### **RECOMMENDED CONDITIONS OF SITE PLAN APPROVAL 500 COPPER CREEK DRIVE (Box Grove Developments Inc.)**

#### **TOWN OF MARKHAM FILE NUMBER SC 08-121694**

**Re: Box Grove Hill Developments Inc.  
Application for Site Plan Approval – Mixed Use Office Retail  
Development at NW corner of Donald Cousens Parkway and Copper  
Creek Drive (File SC 08-121694)**

FIGURE No.4

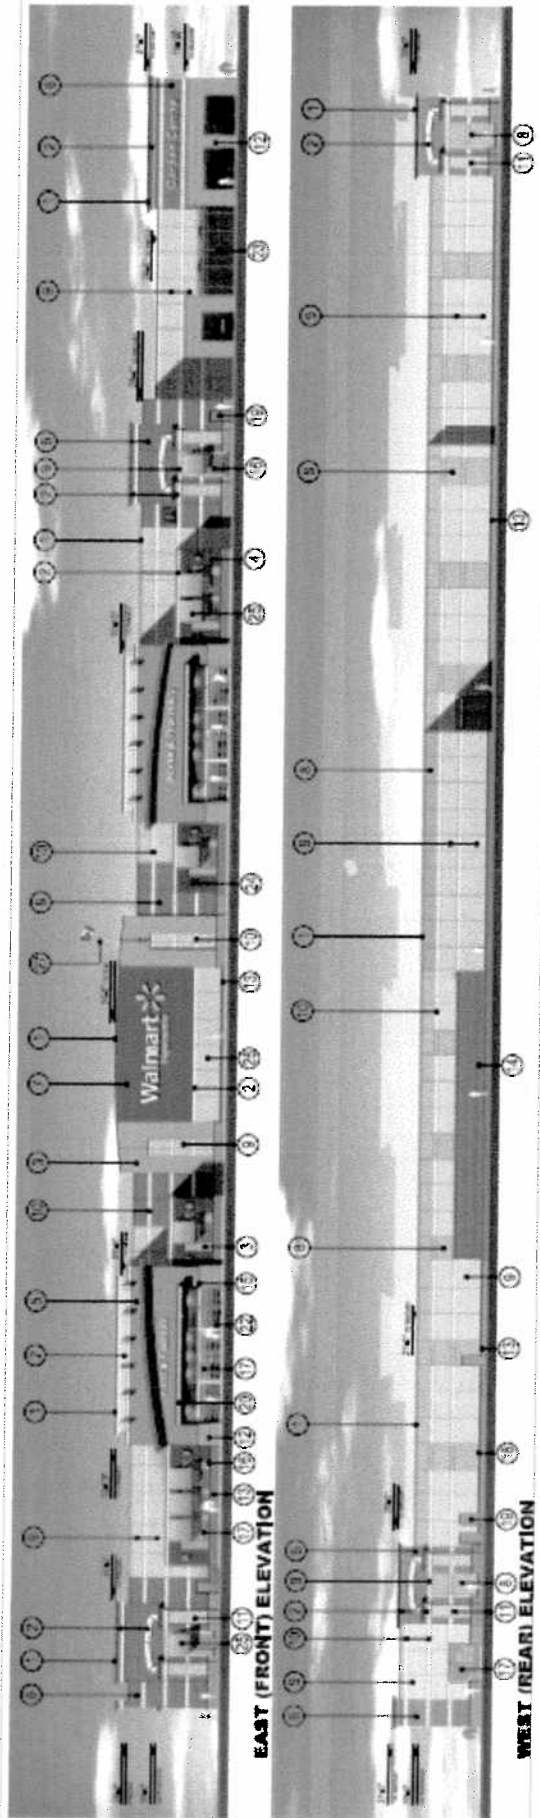
5. That the Owner shall submit revised drawings showing that the proposed garbage enclosures are fully enclosed roofed structures made of materials that match the main structures and integrated with the main building.

9. That the Owner agrees to continue to work with the Town to explore additional opportunities to implement additional landscape islands within the parking lot and other modifications to the site plan as may be appropriate, to the satisfaction of the Director of Planning and Urban Design or her designate;

13. That the Owner shall provide 6 permanent taxi stands, to be shown on the site plan, in a location to the satisfaction of the Town;
14. That the Owner shall provide a minimum of one bicycle rack for each retail pad, in locations to the satisfaction of the Town;
